## 5051-5053 FAUNTLEROY WAY SW

**Project #:** #3034217-LU & #3036305-LU

**Packet Type:** Design Recommendation

1 Street View looking Northwest

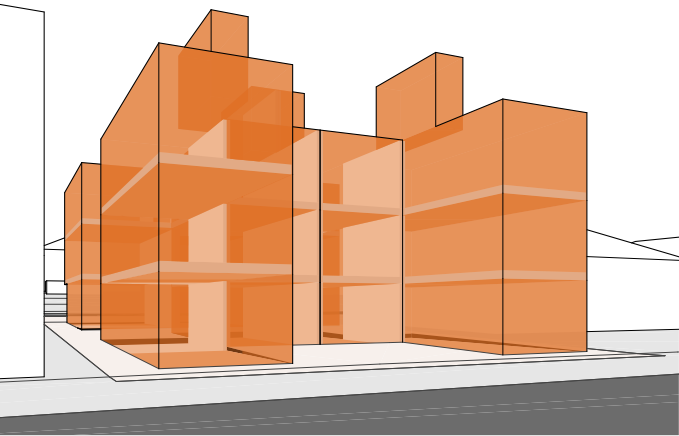
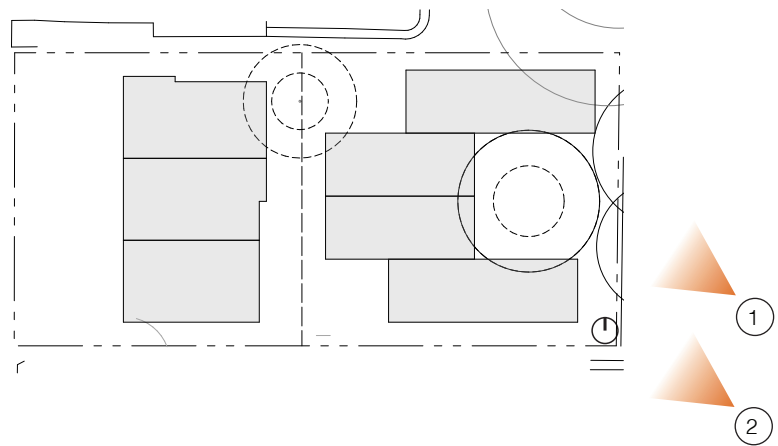
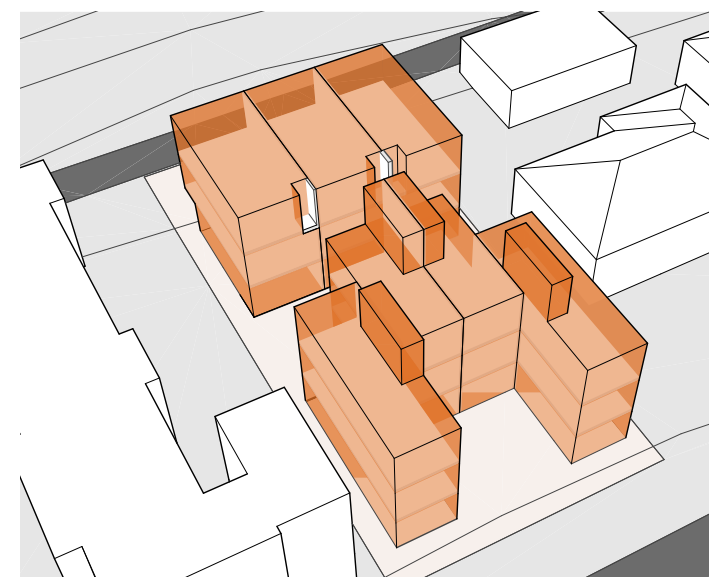
**Staff supports the applicant’s preferred massing option 3 in order to retain the exceptional trees, provide additional façade modulation, allow for multiple courtyard like settings, and give the east middle rowhouses more access to daylight.(CS1-B-2, DC3-C-2, DC4-D-4)**
- b.

- The applicant has developed the preferred massing Alternative 3. The additional facade modulation and courtyard spaces contribute to a better site strategy and solution. (CS1-B-2, DC3-C-2, DC4-D-4)

1 Section Perspective looking Northwest

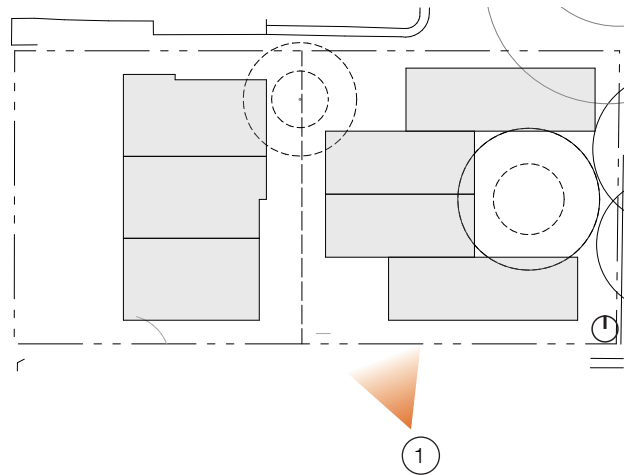
**Study the distance between the two main masses of townhouses 1-3 and rowhouses 2-3 to determine if the space can be widened to provide a meaningful open space between the two structures. (DC3-C-2)**
- a.

- The space between the two main masses of townhouses 1-3 and rowhouses 2-3 is compressed in response to the street-facing courtyard and exceptional tree in front of rowhouses 2-3. The design has evolved to holistically improve the courtyard space and pedestrian experience. The courtyard is widened at the south end between townhouses 1-2 and rowhouses 3-4. The ground floor of townhouse 3 and half of townhouse 2 has been recessed 1'-6" to expand the ground space. In addition, the trash storage has been reconfigured (see response to 4a below) expanding the overall courtyard space to the north and providing additional space for the larger tree to be relocated to the north side of the courtyard space. This opens up the courtyard space to the south adjacent to the shared pedestrian walkway/easement along the south property line. (DC3-C-2)

1 Courtyards Axonmetric View

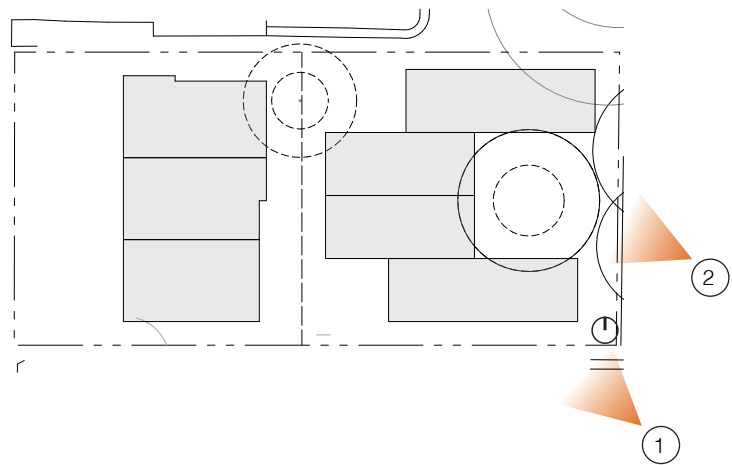
**The EDG packets speak to the benefits of the amenity space provided and retaining the exceptional trees. Ensure the open space is activated, visually appealing, and of a quality that will entice residents to utilize the spaces. (DC3-B-1)**
- b.

**The placement of benches as a means of activation to the east courtyard is a pleasant addition. (DC3-B-1)**
- c.

- Each rowhouse includes a large windows and a sliding patio door that connect the unit's interior to this space visually and physically. Windows connect at all floors to provide opportunity for individuals to have eyes on the space and encourage connectivity between residents. Horizontal wood stained siding highlights this space, creating a textured backdrop for the amenity space and exceptional trees. (DC3-B-1)
- Benches have been retained in the east courtyard to take advantage of the shade and help activate the space. (DC3-B-1)

1 View of South Courtyard

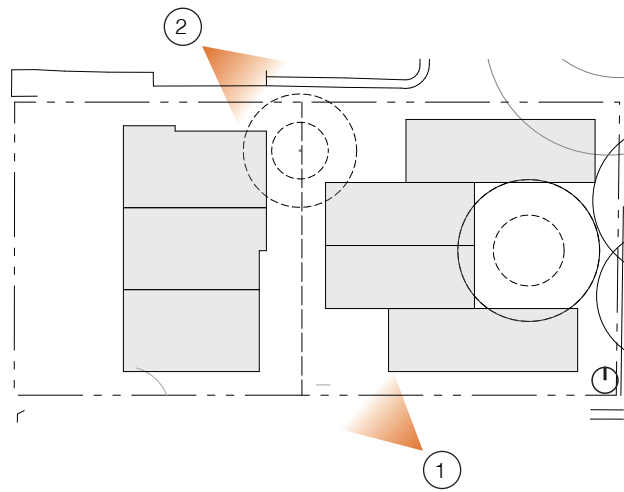
**Place bio-retention planters thoughtfully where they will not be a nuisance or impede upon the quality of the open space or circulation. (DC3-B-1)**
- d.

- Drainage solutions, including bio-retention planters, will be resolved as part of the building permit submission process and will be added to the MUP documents at that time. They will be designed to support the use of the courtyard and circulation spaces. (DC3-B-1)

5 Rendered Landscaped Plan

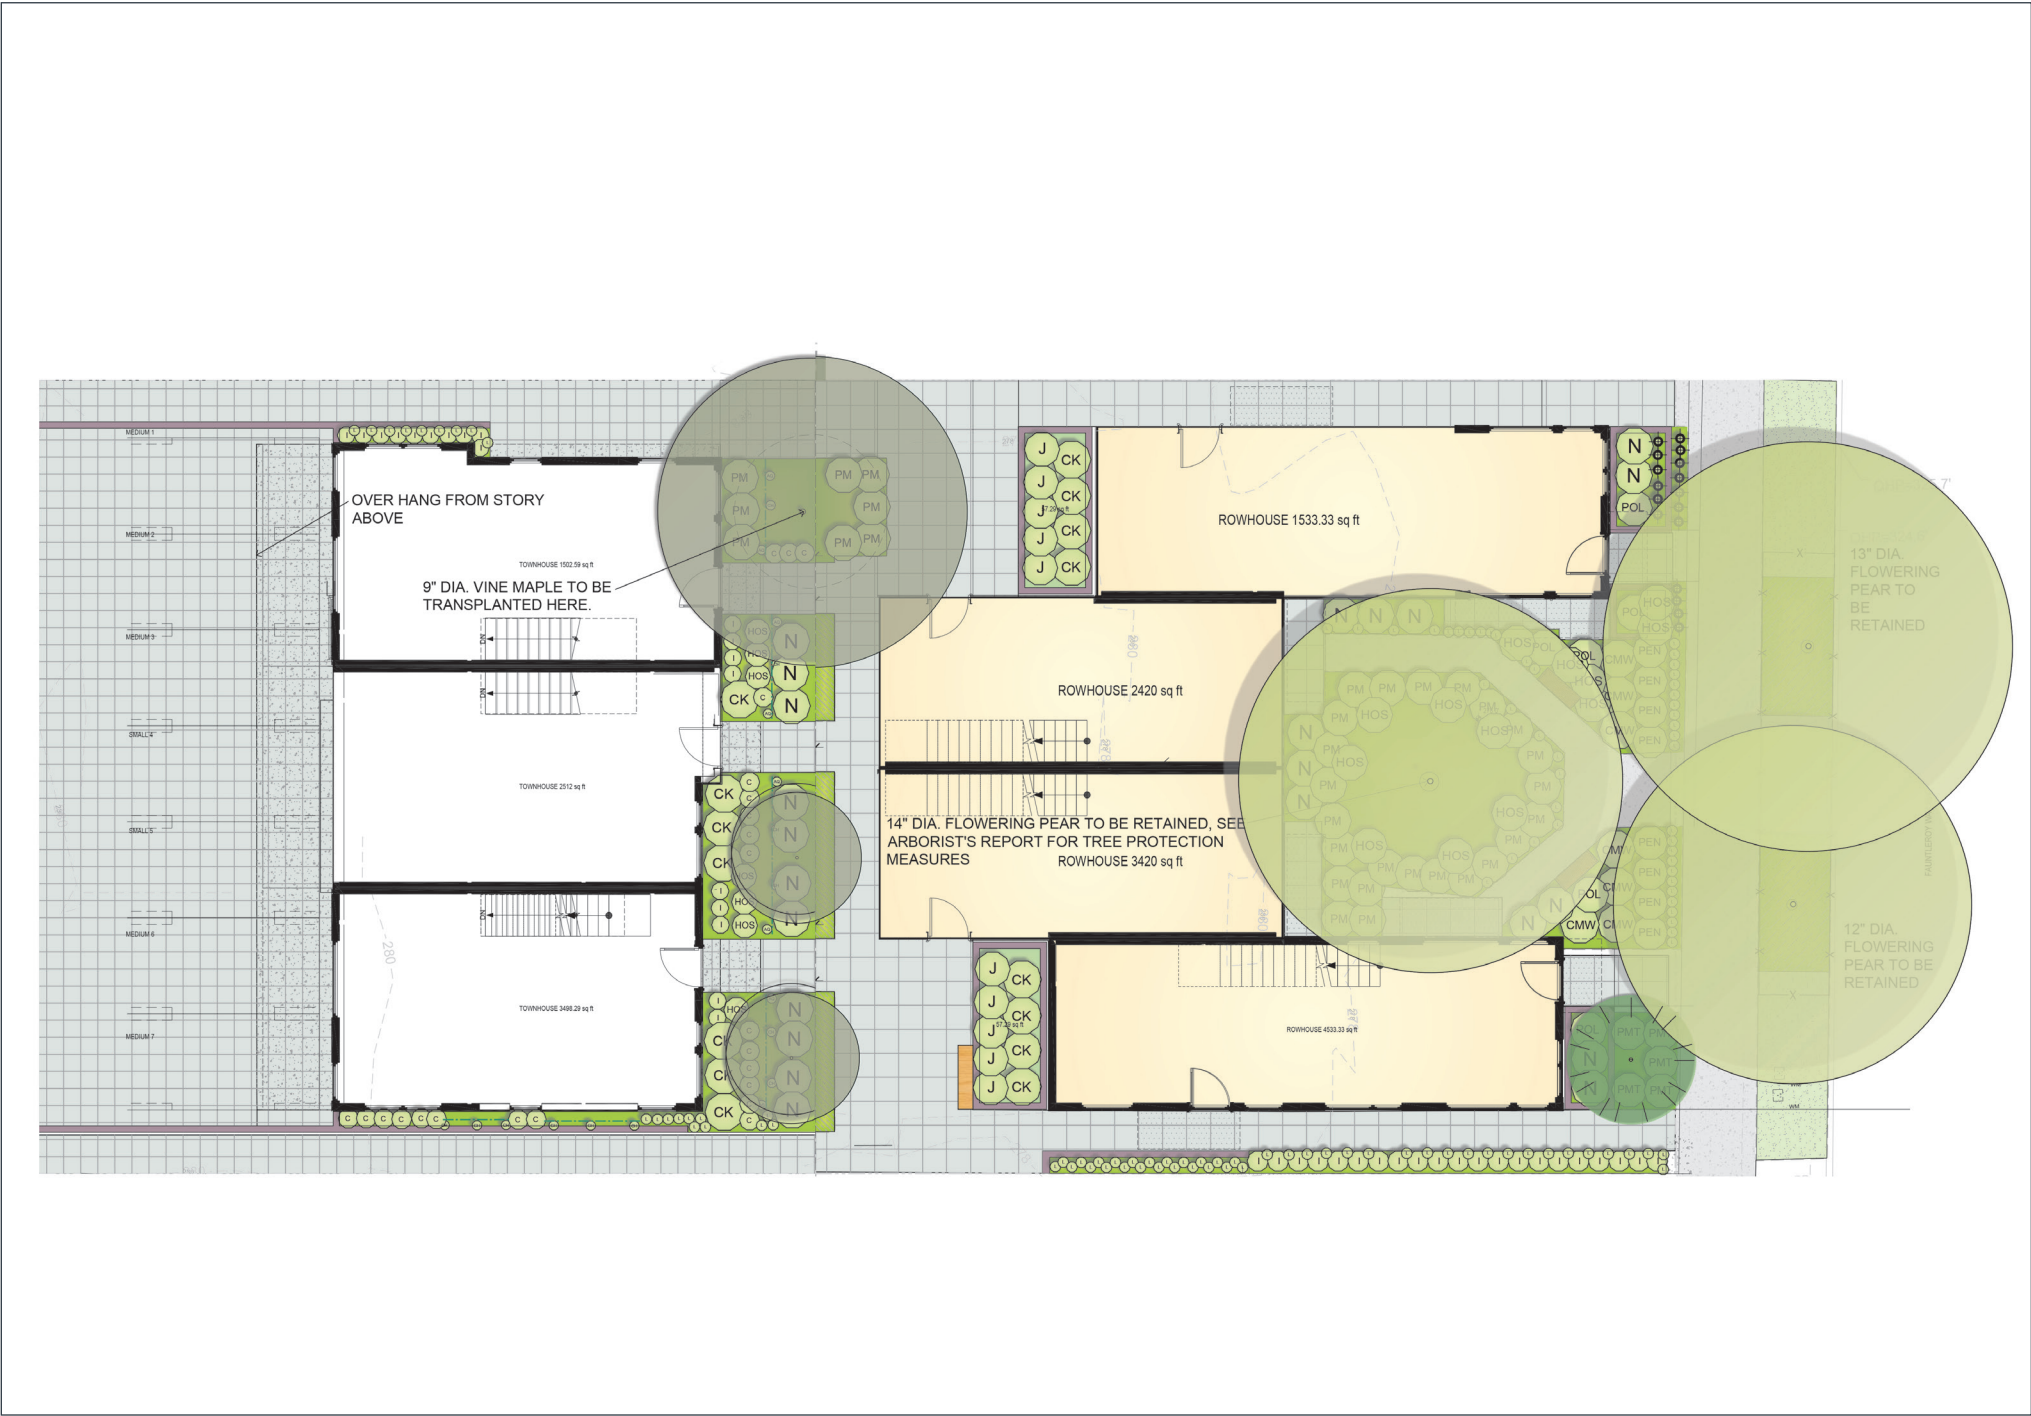
**Provide thoughtful, lush landscaping to define spaces and offer seasonal interest that adds to the quality of the development as a whole. (DC4-D-1)**

- Lush landscaping has been provided, refer to the Landscape sheets. The design supports the use of the courtyards and other amenity areas and features the large trees that remain on site. (DC4-D-1)

2 South Pedestrian Path Diagram

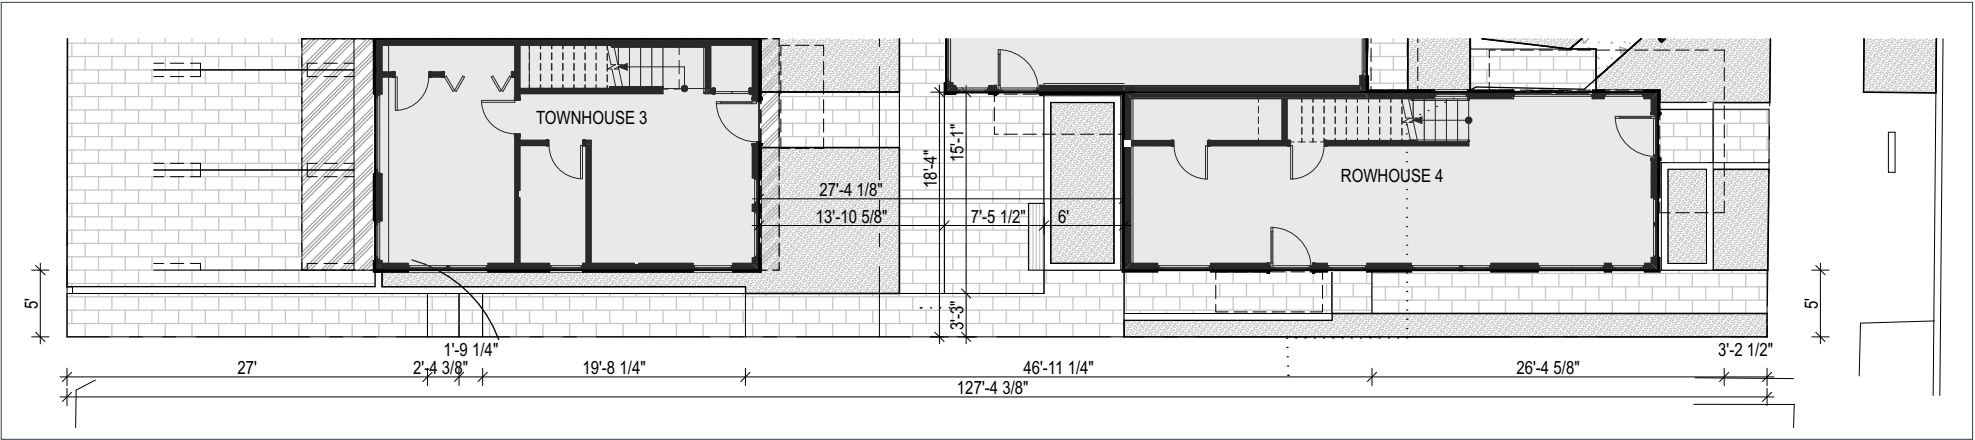
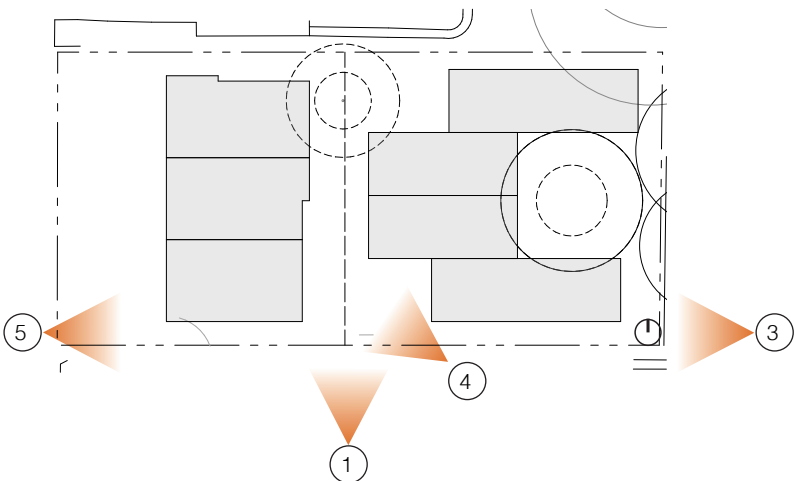
- a. **Widen the north/south path at the south end of the properties between Rowhouse 4 and Townhouse 3 to mitigate the pinch point of circulation at this location. (PL1-B-2)**
- a. The pinch point along the north/south path at the south end of the properties between Rowhouse 4 and Townhouse 3 has been widened to nearly 12 feet, providing the opportunity for a table and chairs as well as circulation space. This creates an inviting entry into the courtyard. In addition, the existing exceptional vine maple tree that the arborist identified as movable on site, was previously planned for this area, creating the pinch point. It is now proposed to be located in the north end of the properties where the trash storage has been redesigned (see 4a below). (PL1-B-2)

- The pinch point along the north/south path at the south end of the properties between Rowhouse 4 and Townhouse 3 has been widened to nearly 12 feet, providing the opportunity for a table and chairs as well as circulation space. This creates an inviting entry into the courtyard. In addition, the existing exceptional vine maple tree that the arborist identified as movable on site, was previously planned for this area, creating the pinch point. It is now proposed to be located in the north end of the properties where the trash storage has been redesigned. (PL1-B-2)
